Project	IEEE 802.16 Broadband Wireless Access Working Group < http://ieee802.org/16 >	
Title	Frame Structure for Bi-Directional Relay	
Date Submitted	2008-09-05	
Source(s)	Masato Okuda, Yanling Lu and Kevin Power Fujitsu	E-mail: okuda@jp.fujitsu.com * http://standards.ieee.org/faqs/affiliationFAQ.html >
Re:	SDD Session 56 Cleanup: Relay Frame Structure; in response to the IEEE 802.16m-08/033, Call for Contributions and Comments on Project 802.16m System Description Document (SDD)"	
Abstract	To propose relay frame structure to improve bandwidth usage efficiency.	
Purpose	To propose relay frame structures to be adopted to the 802.16m SDD	
Notice	<i>This document does not represent the agreed views of the IEEE 802.16 Working Group or any of its subgroups. It represents only the views of the participants listed in the "Source(s)" field above. It is offered as a basis for discussion. It is not binding on the contributor(s), who reserve(s) the right to add, amend or withdraw material contained herein.</i>

Frame Structure for Bi-Directional Relay

Figure 1 Relay Frame structure option 1

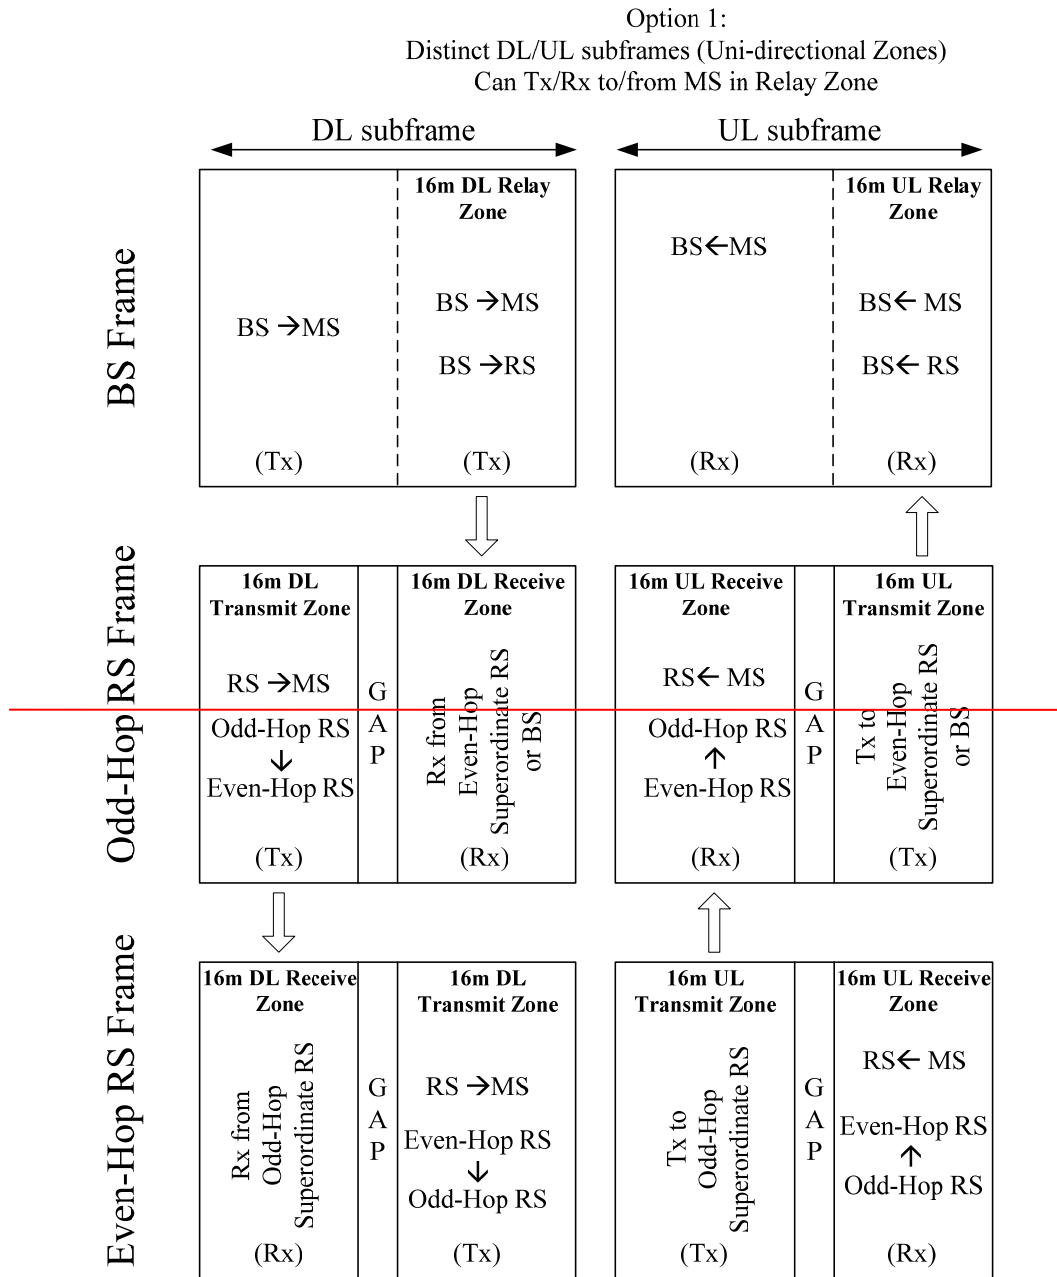
[Delete the following figure and text at page 40-41 in the subclause 11.4.4 (Relay Support in Frame Structure)]

Definitions corresponding to Option 1 shown in Figure 23

- DL Relay Zone: An integer multiple of subframes located in the 16m zone of the DL of the BS frame, where a 16m BS can transmit to the 16m RSs and the 16m MSs.
- UL Relay Zone: An integer multiple of subframes located in the 16m zone of the UL of the 16m BS frame, where a 16m BS can receive from the 16m RSs and the 16m MSs.
- DL Transmit Zone: An integer multiple of subframes located in the 16m zone of the DL of the 16m RS frame, where a 16m RS can transmit to subordinate 16m RSs and the 16m MSs.
- DL Receive Zone: An integer multiple of subframes located in the 16m zone of the DL of the 16m RS

~~frame, where a 16m RS can receive from its superordinate station.~~

- ~~• UL Transmit Zone: An integer multiple of subframes located in the 16m zone of the UL of the 16m RS frame, where a 16m RS can transmit to its superordinate station.~~
- ~~• UL Receive Zone: An integer multiple of subframes located in the 16m zone of the UL of the 16m RS frame, where a 16m RS can receive from its subordinate 16m RSs and the 16m MSs.~~
